# BAKER STREET SUBDIVISION (MINOR PLAT)

## SUMMARY

**Property Location:** 1311 S. Osceola Ave.  
(southeast corner of S. Osceola Ave. and  
Baker St., between Briarcliff Dr. and Purdue  
St.) (Parcel #36-22-29-0000-00-070; 0.33  
acres, District 4).

PROPOSED  
PLAT

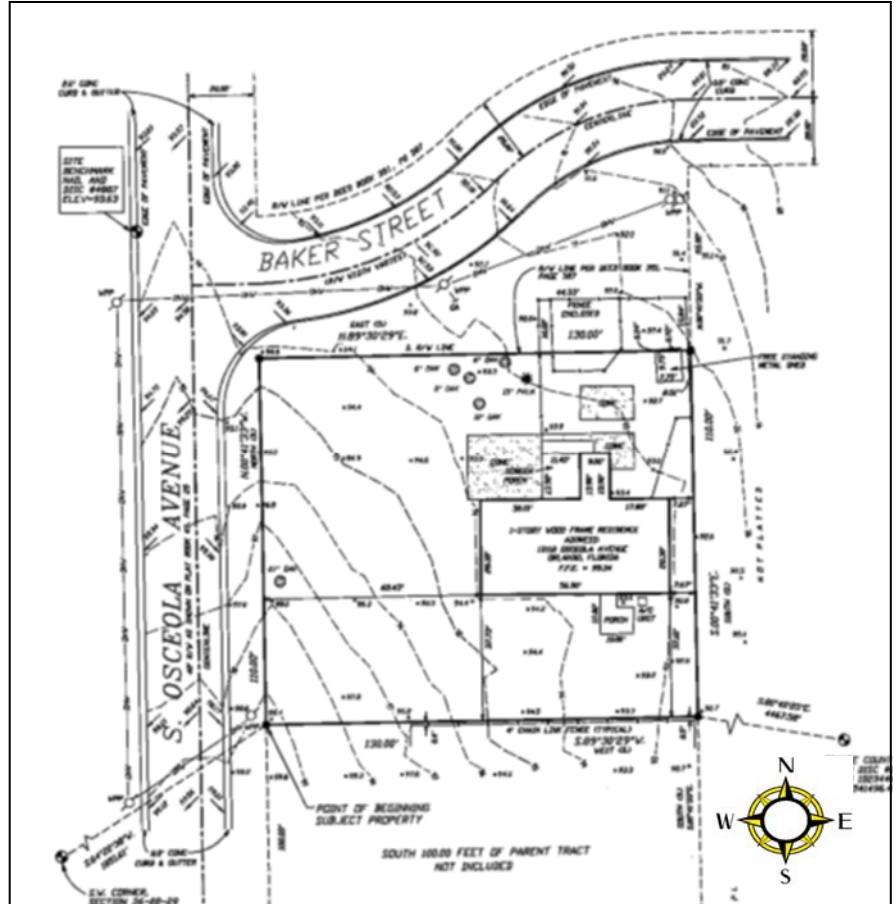
Sewer - A gravity sewer connection may not be available to serve the easterly new parcel created by this subdivision. Please contact the Wastewater Division to discuss sanitary sewer availability.
